## September 15, 2016 BOARD OF COUNTY COMMISSIONERS ORANGE COUNTY, FLORIDA Y17-704 / ADDENDUM # 1 ORANGE COUNTY CONVENTION CENTER NORTH/SOUTH BUILDING SHOW POWER UPGRADES

This addendum is hereby incorporated into the bid documents of the project referenced above. The following items are clarifications, corrections, additions, deletions and/or revisions to and shall take precedence over the original documents. <u>Underlining</u> indicates additions, deletions are indicated by <u>strikethrough</u>.

SUBSTATION 'A' (SE) SINGLE LINE DIAGRAM

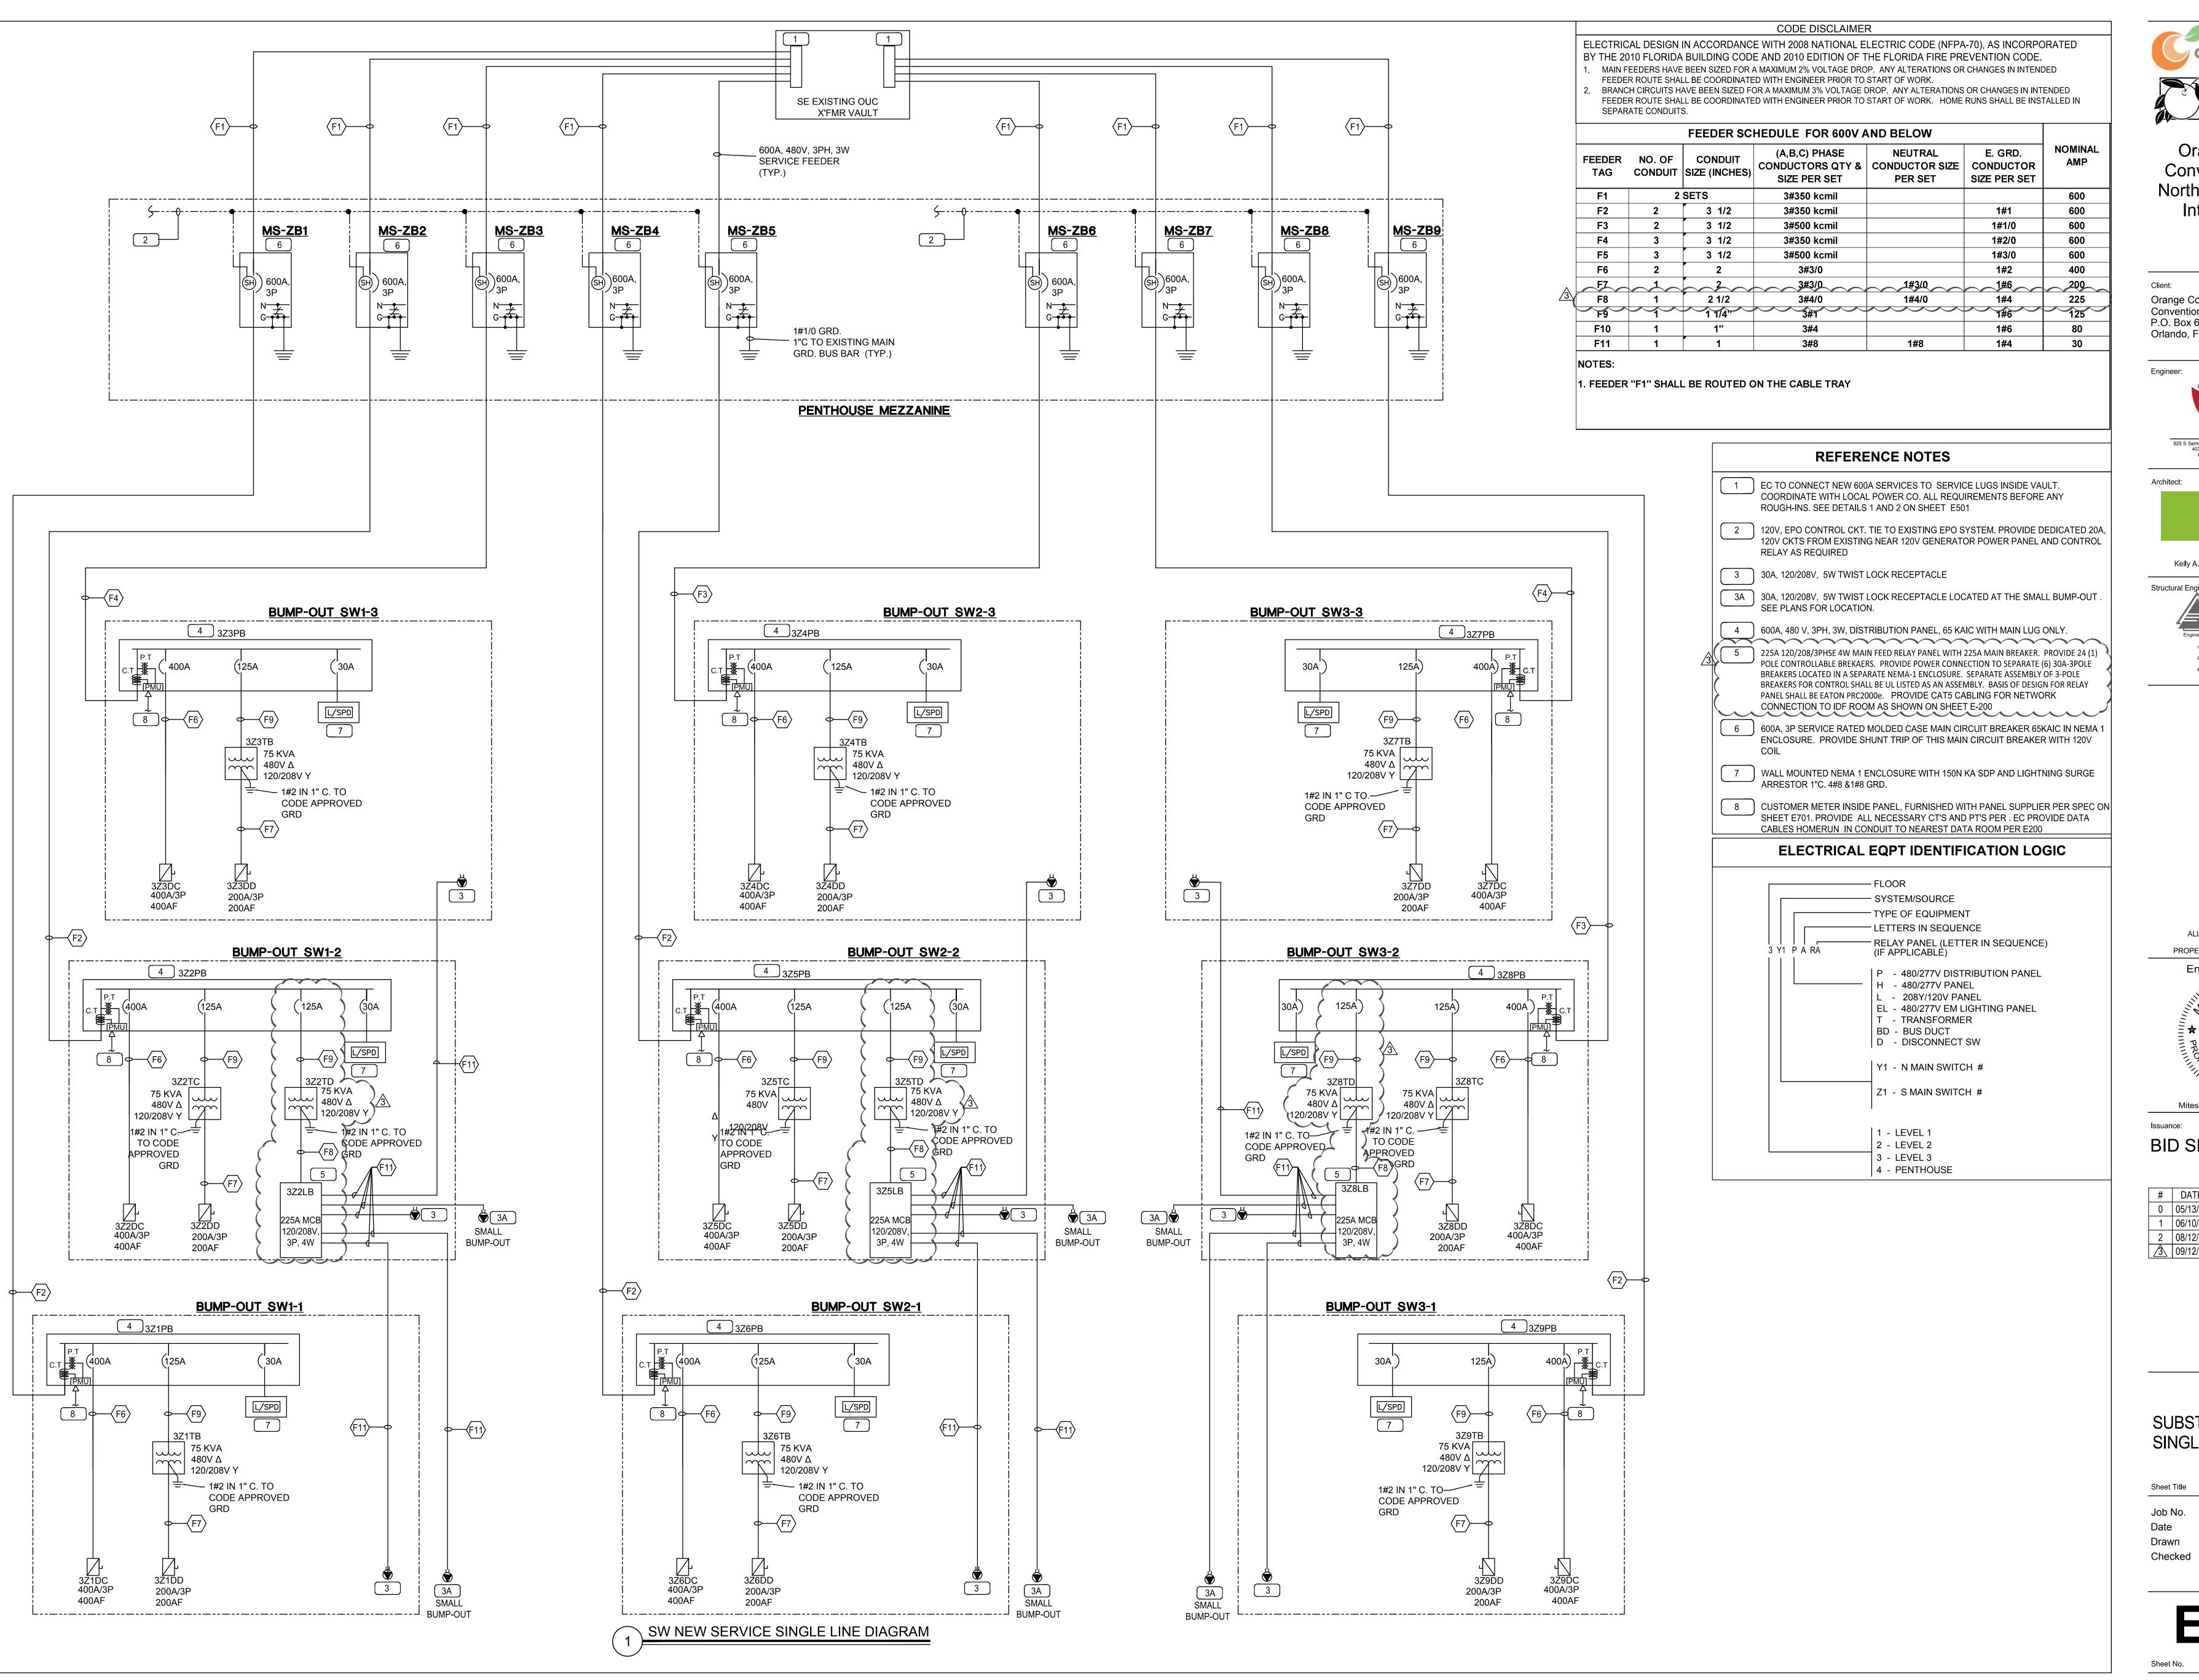
- 1. E-601 Substation 'A' (SE) Single Line Diagram. Description: the revision shows Relay Panel at bump-outs revised information, clouded with Delta 3.
- 2. E-602 Substation 'B' (SW) Single Line Diagram. Description: the revision shows Relay Panel at bump-outs revised information, clouded with Delta 3.
- 3. E-603 Substation 'C' (NE) Single Line Diagram. Description: the revision shows Relay Panel at bump-outs revised information. clouded with Delta 3.

Y17-704-MM ADDENDUM #1 September 15, 2016 twistlock outlets. The relay panels shall be interlocked with a main BMS system/network interface located in the near vicinity of the IDF rooms shown on Drawing E200 using CAT5/6 cabling. The new relay panels basis of design shall be Eaton PowR command with integral controllable breakers. Please see attached revised sheets E601, E602, E603, E604 & E701 indicating new relay panels specification change.

SUBSTATION 'D' (NW) SINGLE LINE DIAGRAM

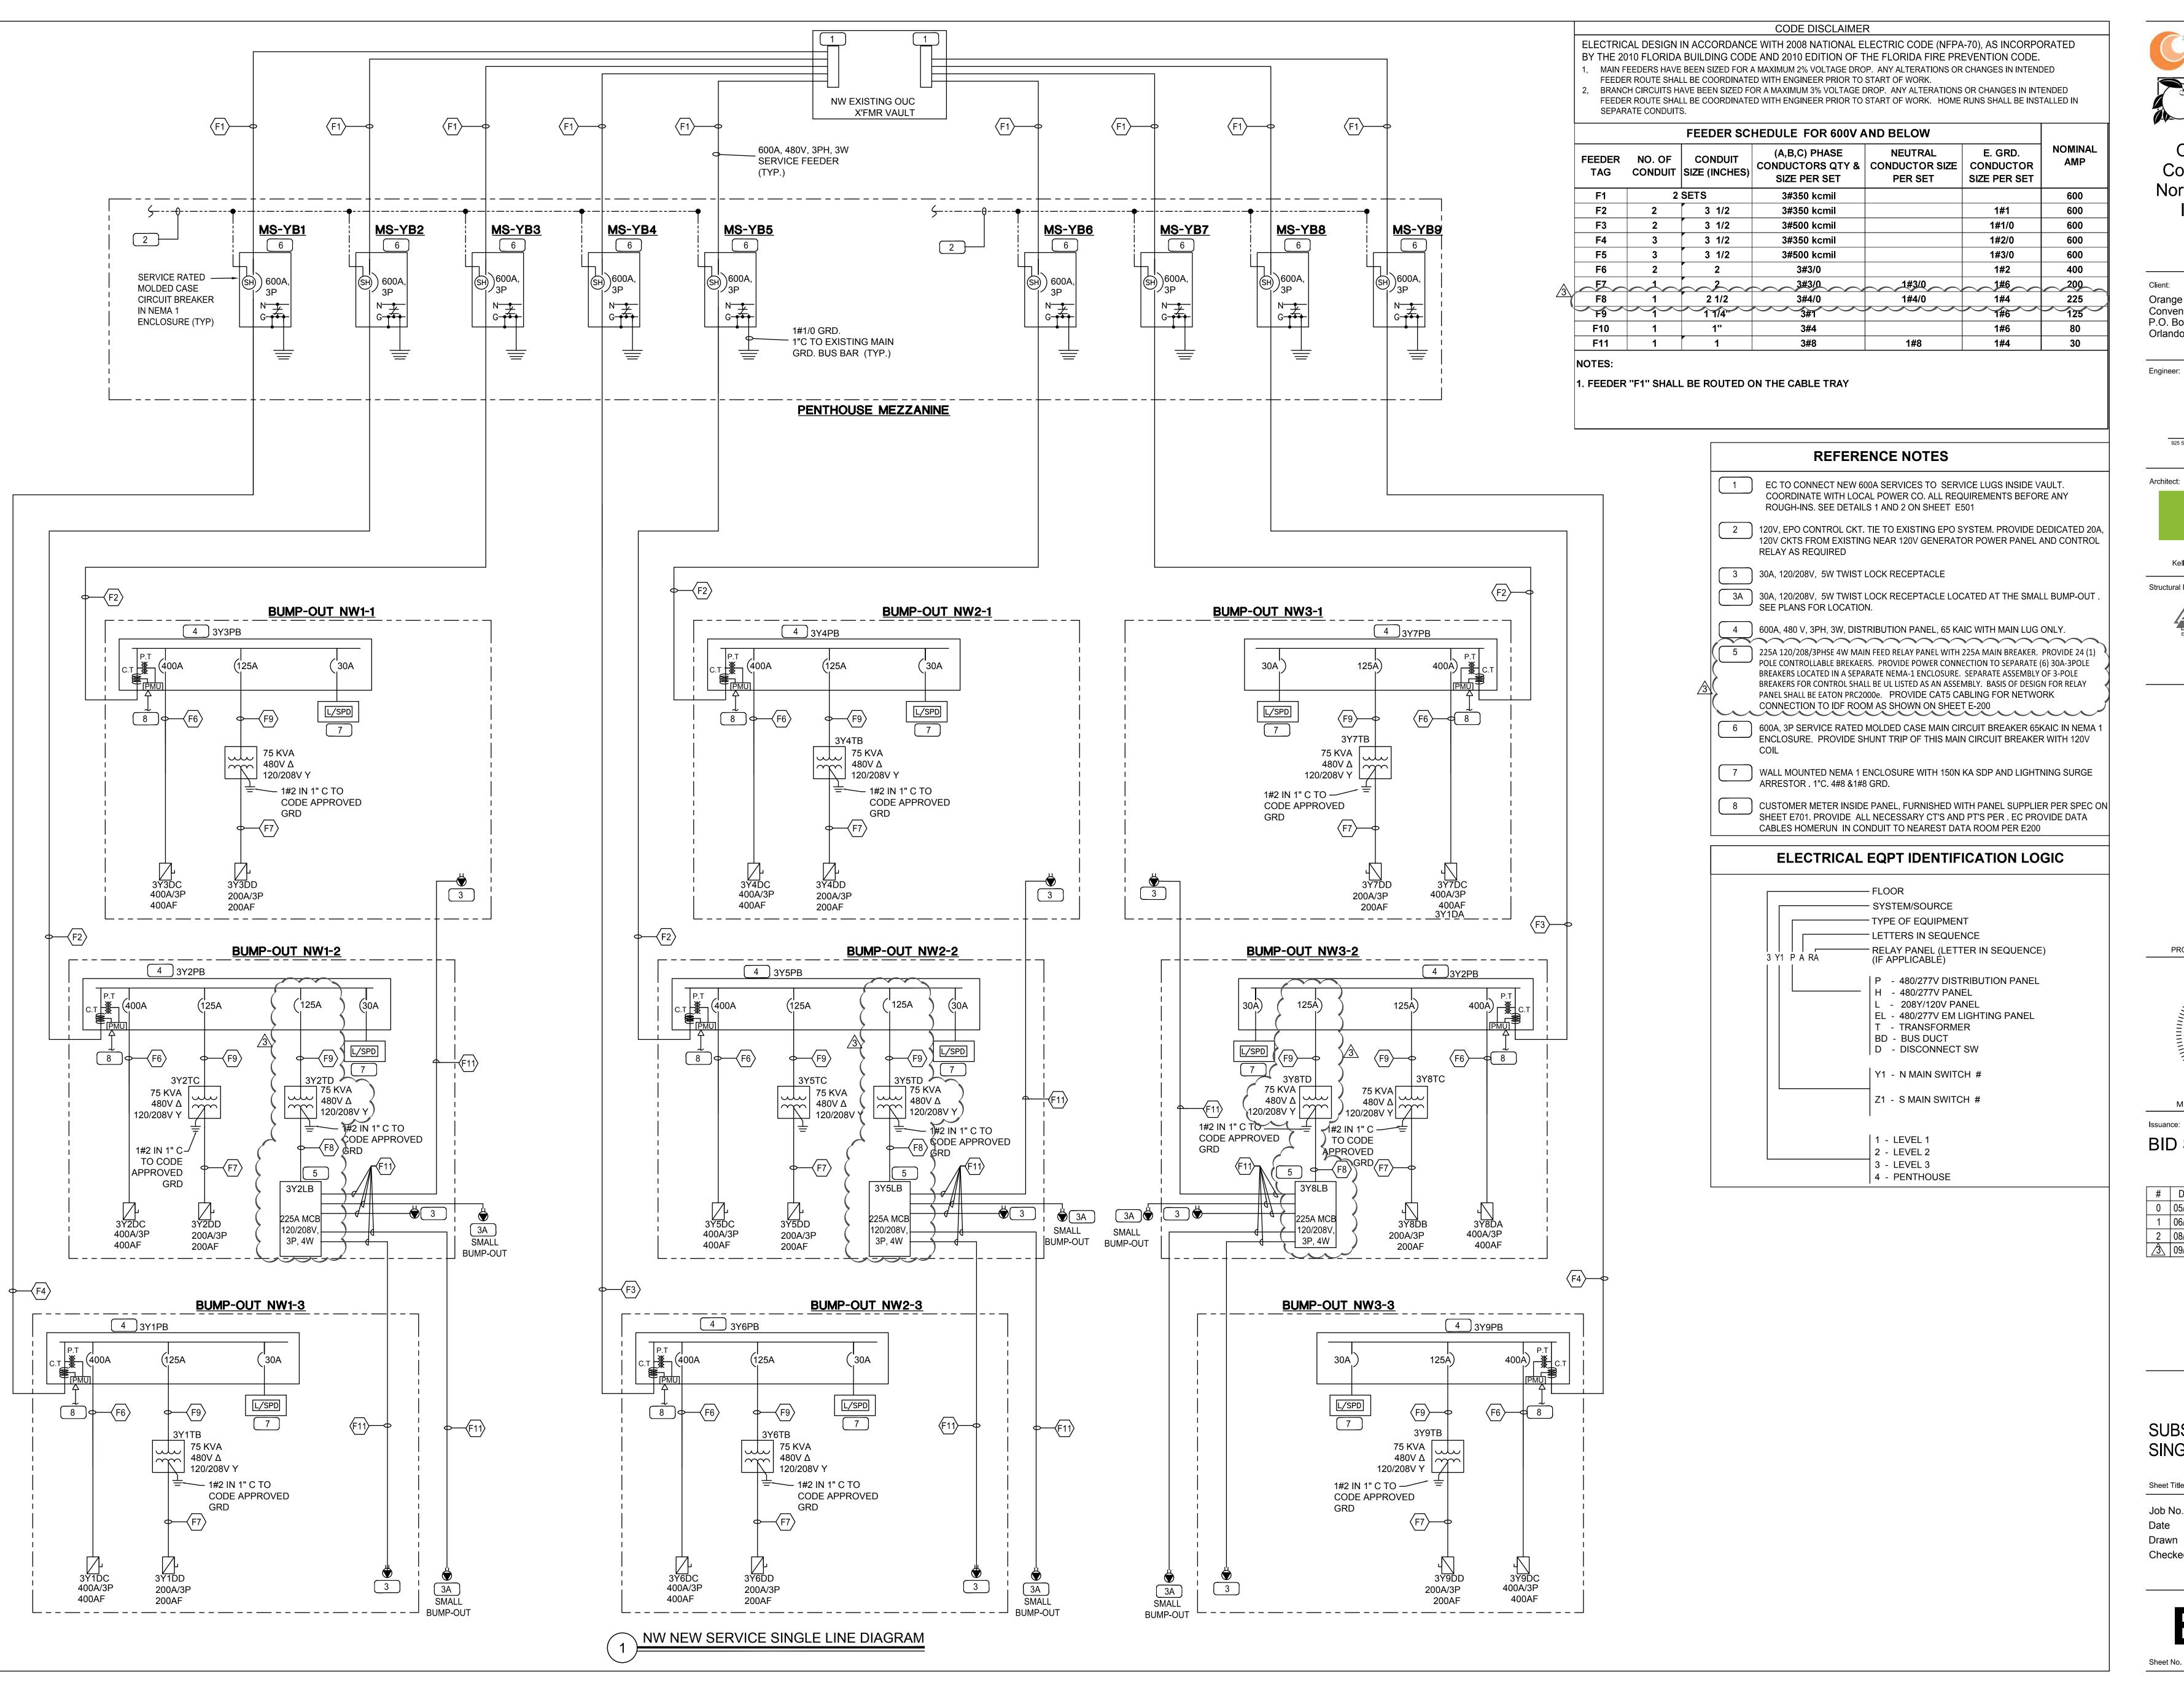
- 4. E-604 Substation 'D' (NW) Single Line Diagram. Description: the revision shows Relay Panel at bump-outs revised information. clouded with Delta 3.
- 5. E-701 Equipment Schedule. Description: the revision shows Relay Panel at bump-outs revised information, revised 75 KVA transformers information, 45 KVA transformers deleted information, clouded with Delta 3.
- E. All other term and conditions of the FBI remain the same.
- F. The Proposer shall acknowledge receipt of this addendum by completing the applicable section in the solicitation or by completion of the acknowledgement information on the addendum. Either form of acknowledgement must be completed and returned not later than the date and time for receipt of the proposal.
